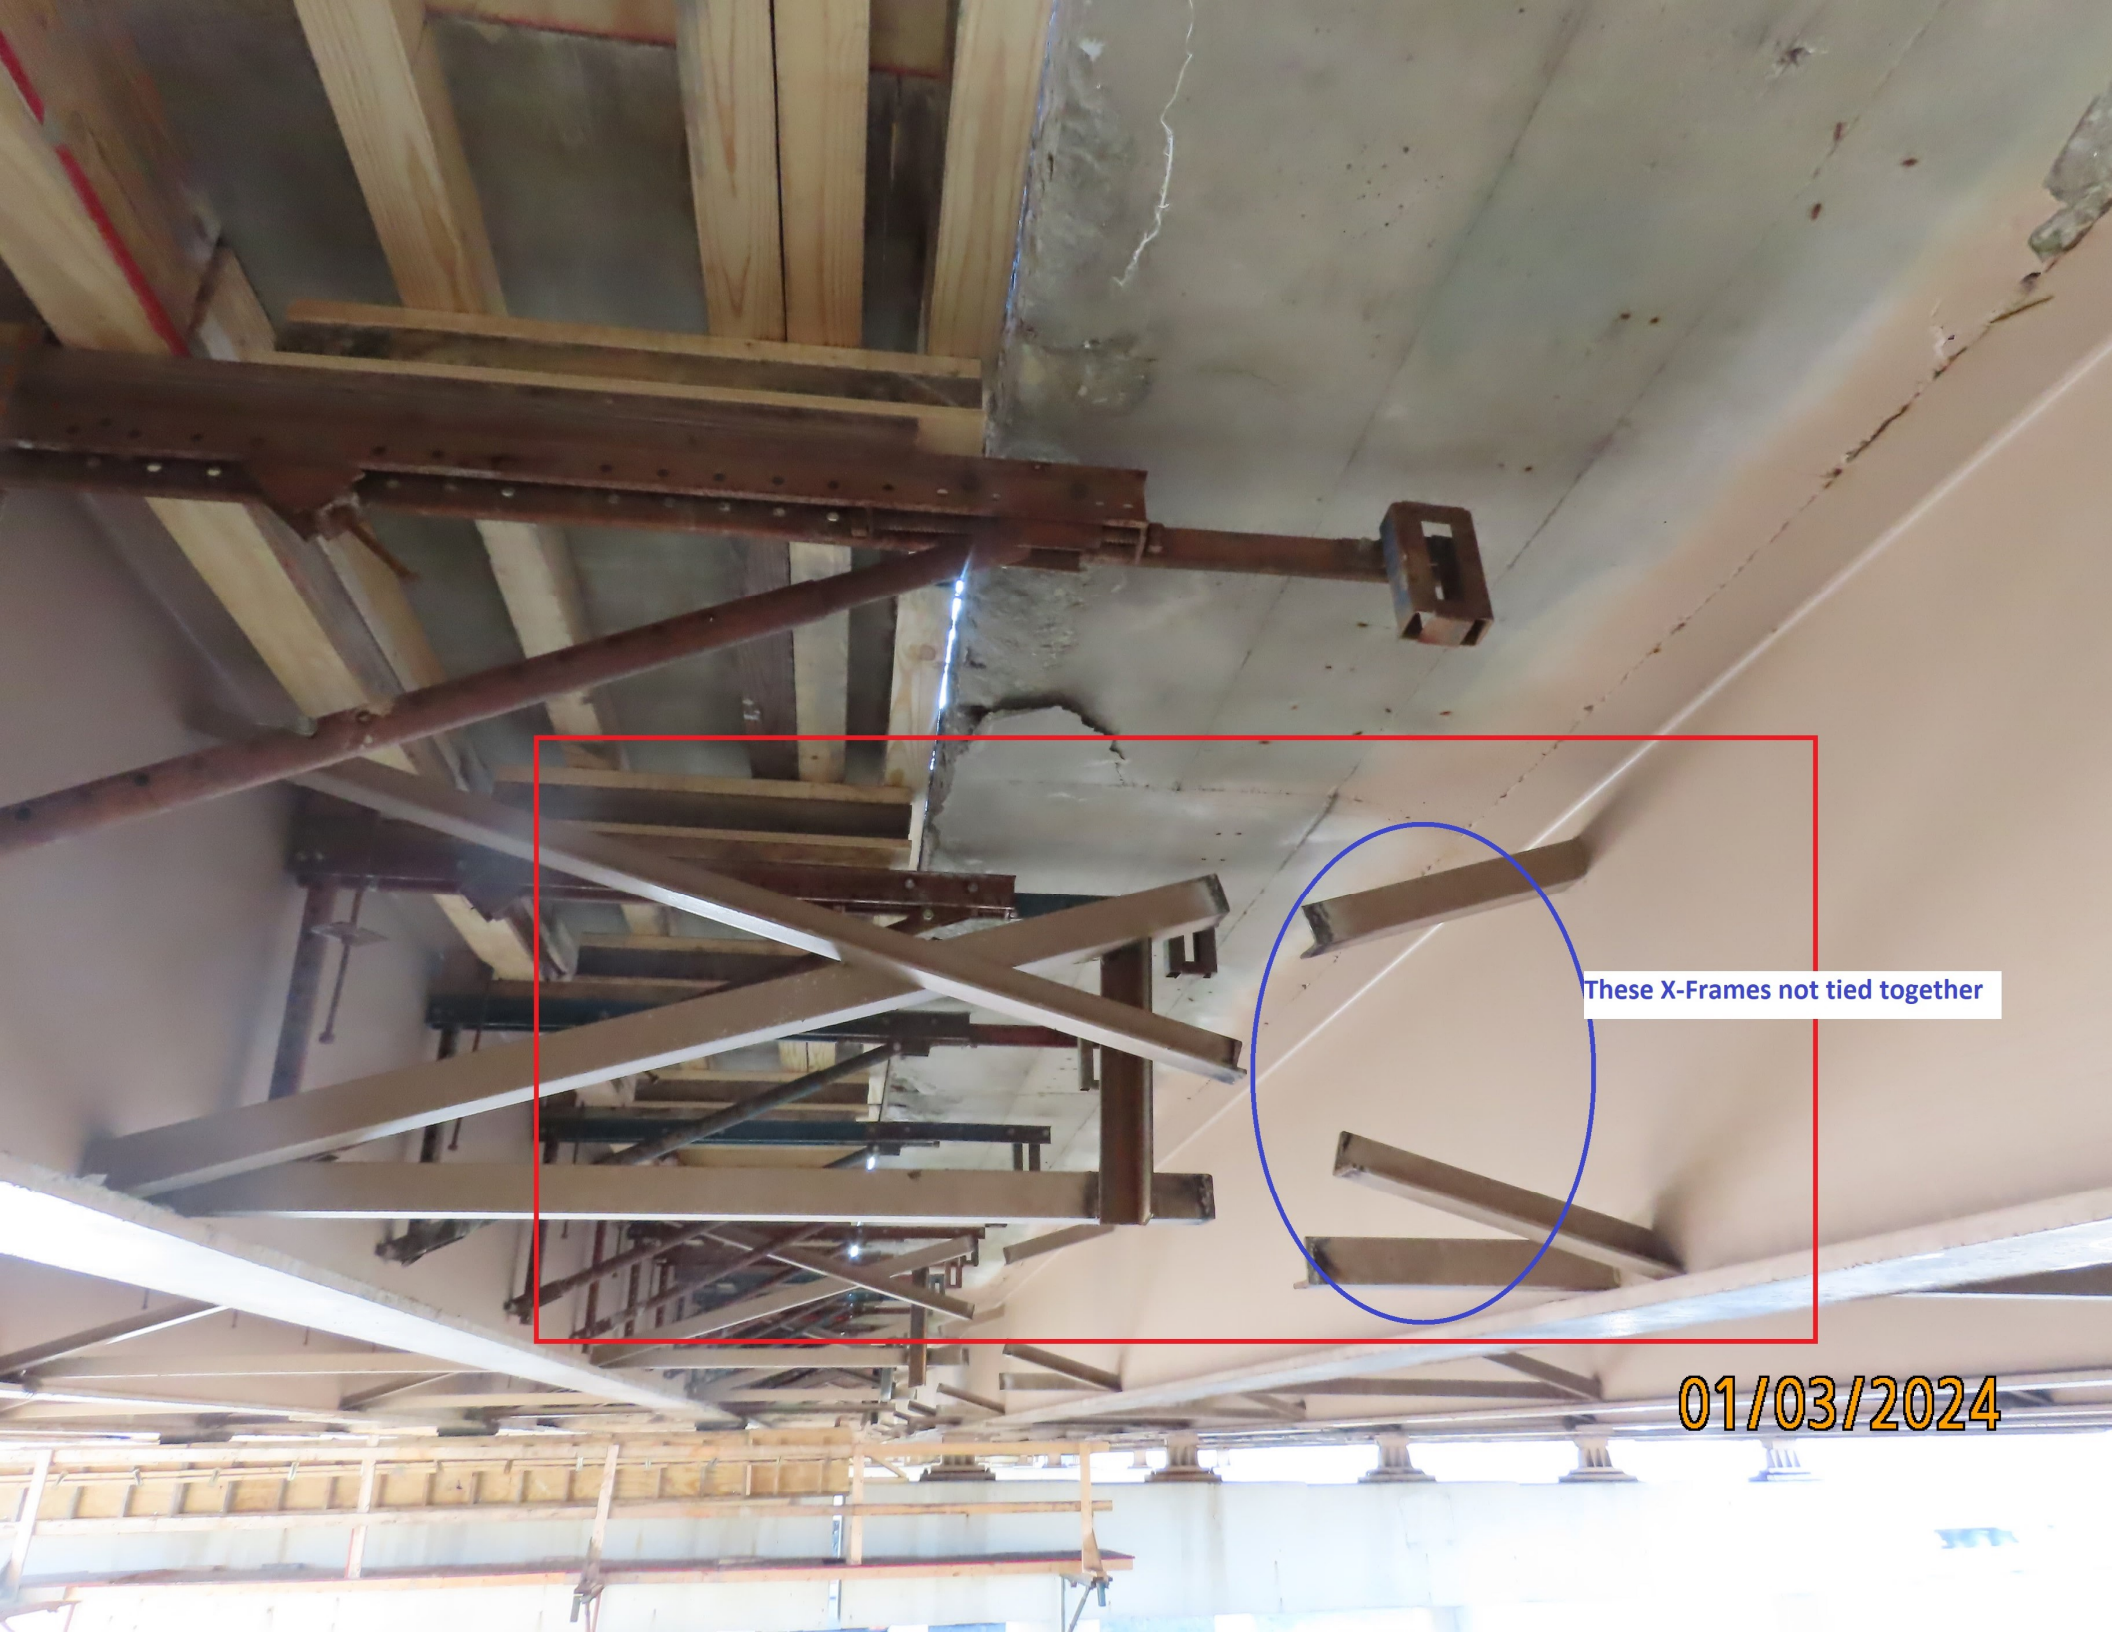
These X-Frames not tied together
